SUBJECT: Forwards util responses to NRC 800301 questions entitled,
 "Clarification of Sept 27 Ltr to Licensees re Demonstration
 of Operability of Purge & Vent Valves," & Allis-Chalmers
 test rept which provides supporting info to responses. *see RPT*

H. B. ROBINSON STEAM ELECTRIC PLANT UNIT NO. 2
DOCKET NO. 50-261
LICENSE NO. DPR-23
CONTAINMENT PURGING AND VENTING DURING NORMAL OPERATION

Response to NRC Questions Entitled "Clarification
of September 27 Letter to Licensees
Regarding Demonstration of Operability of
Purge and Vent Valves"

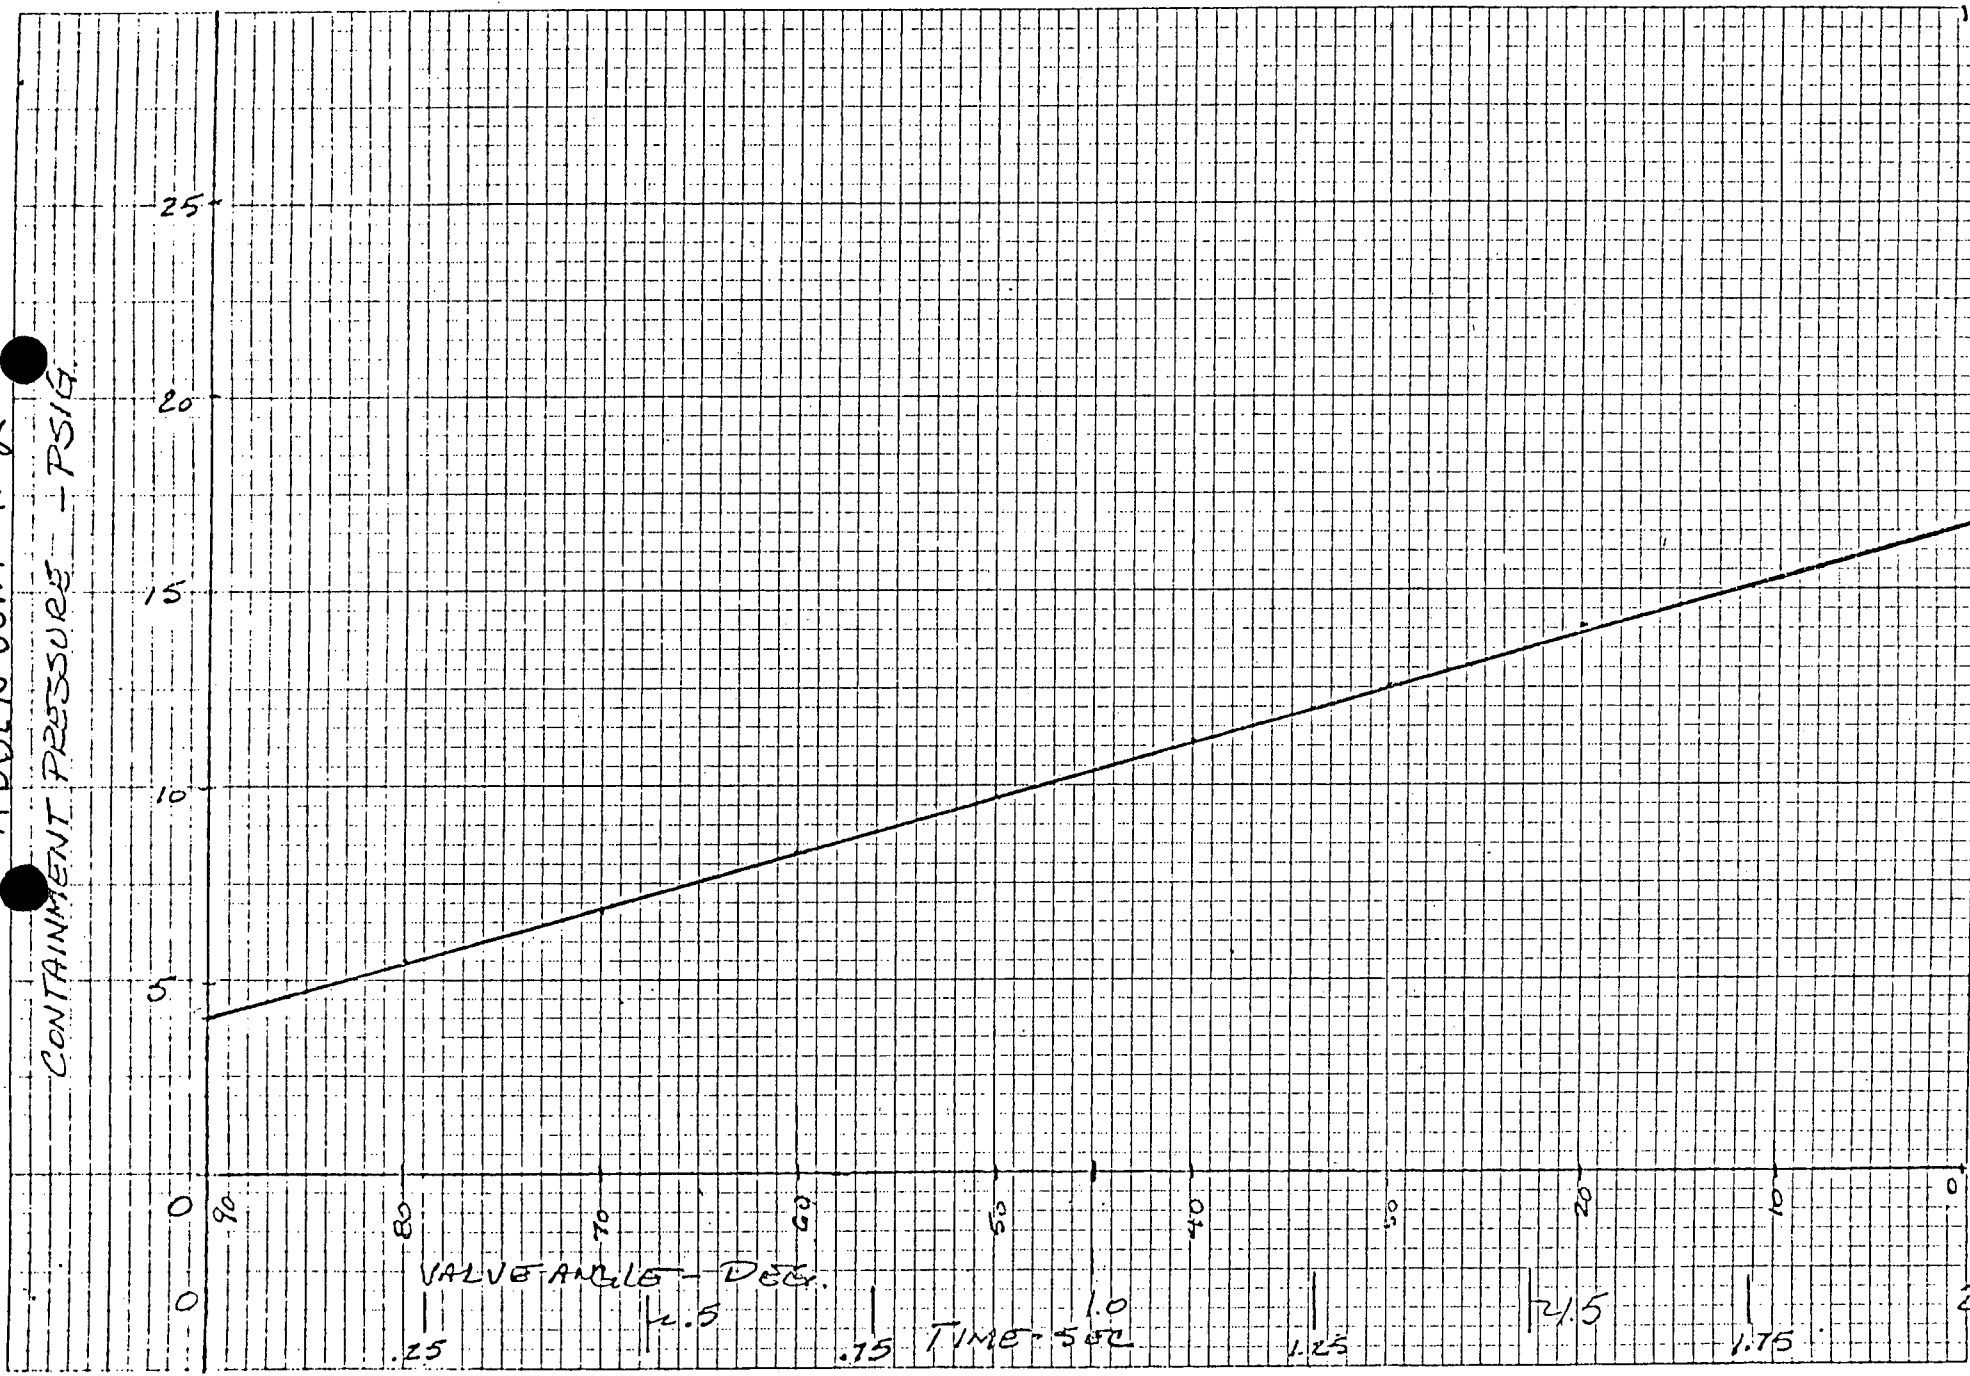
Valve closure rate was a given value and was considered constant from 90° open to closed. The containment pressure response profile was compared to valve closure rate by means of a curve plot, angle of closure versus increasing containment pressure (see Addendum #2).

VALVE NO. V12-6

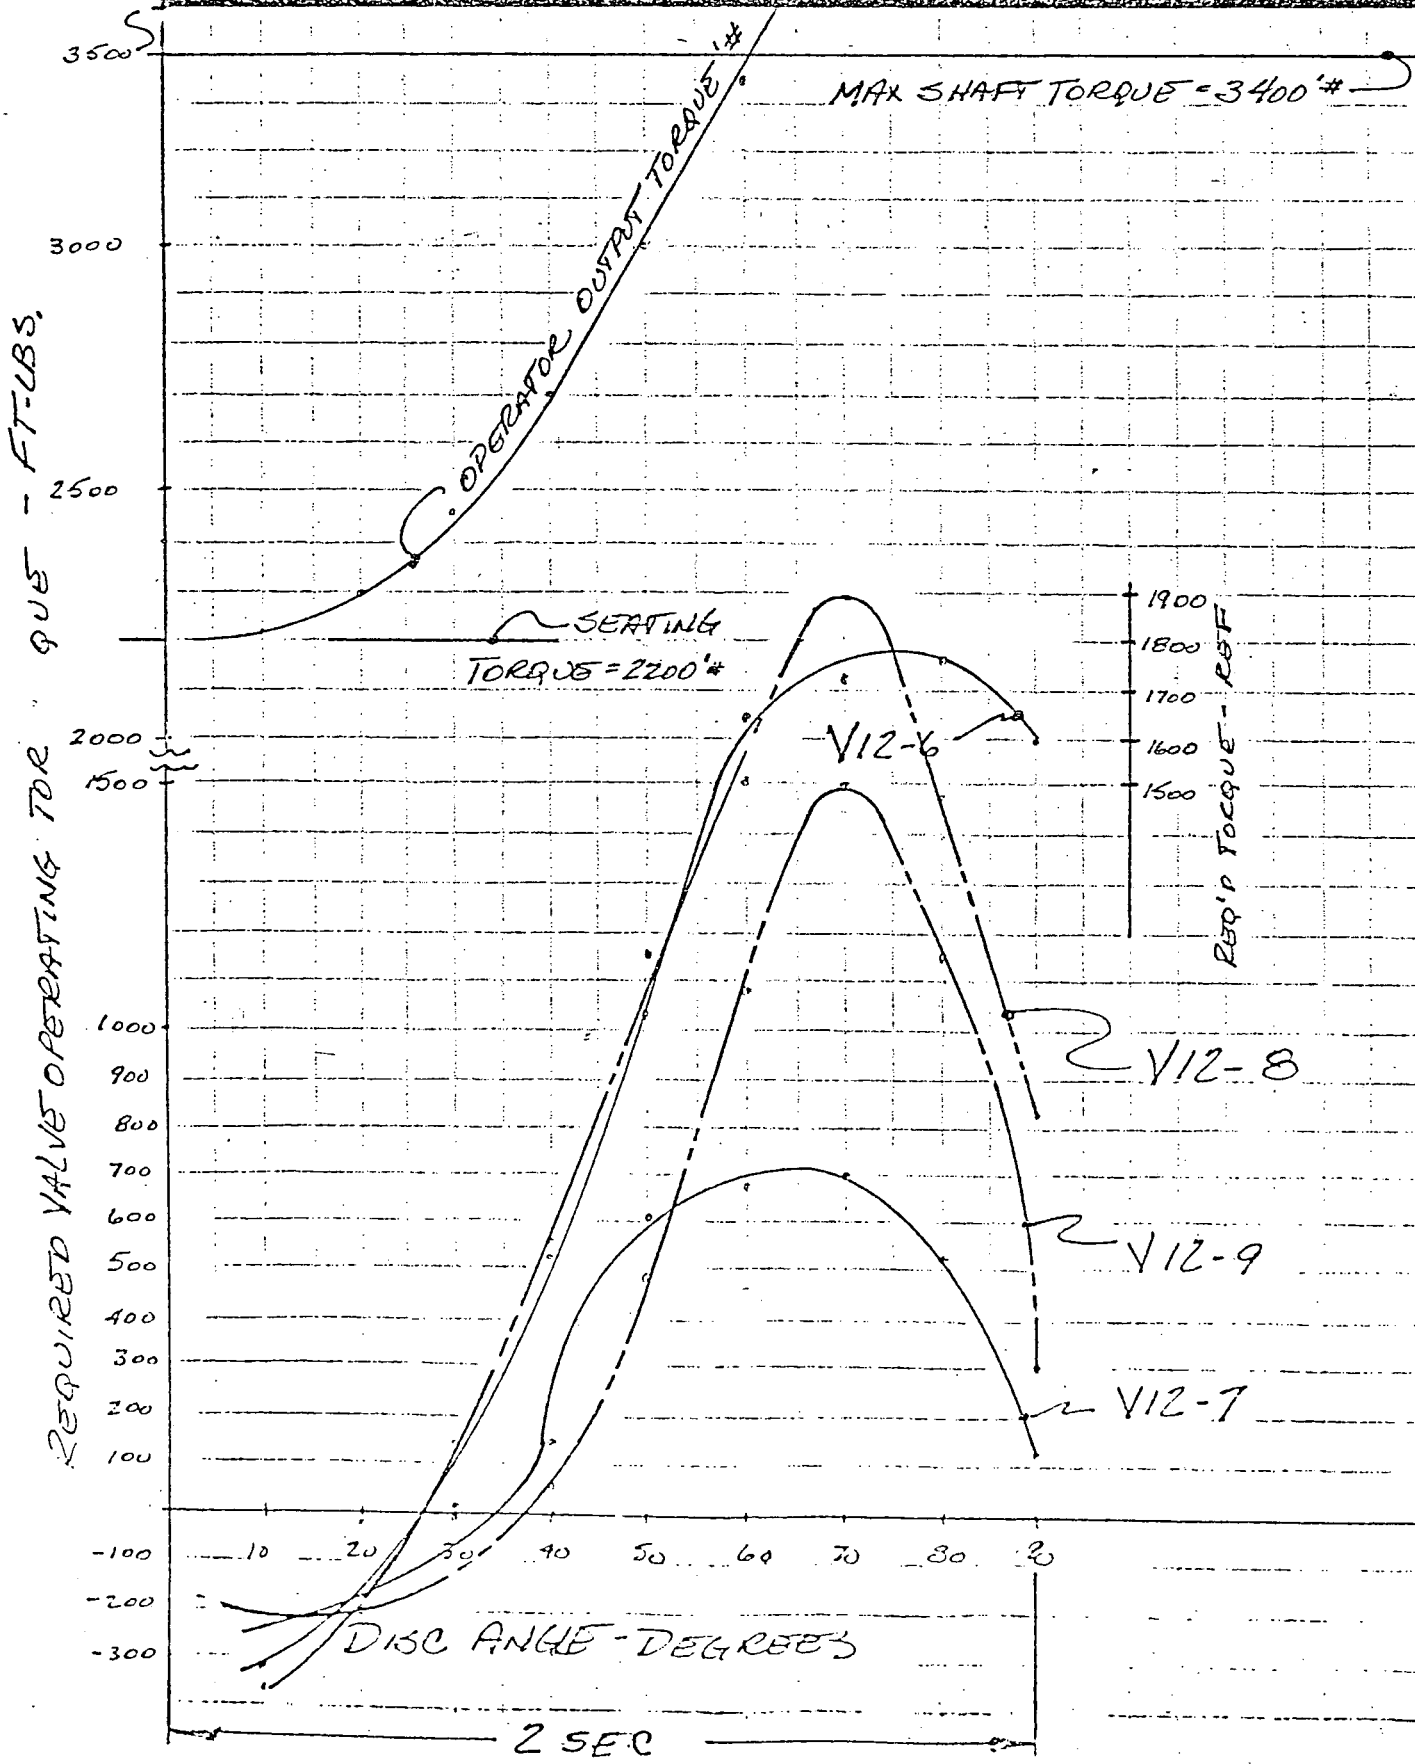
The predicted ΔP capability versus the vane angle of opening have been tabulated on the data sheets enclosed (see Addendum #3).

Maximum ΔP capability is the pressure rating of the valve; for the 42" BFV, the operating pressure rating is 50 psig, but proof of design test pressure (maximum without structural failure) would be 100 psig differential across the valve. For the 6" BFV, 150 psig is maximum operating pressure, with 300 psig differential being the maximum for proof of design test purposes.
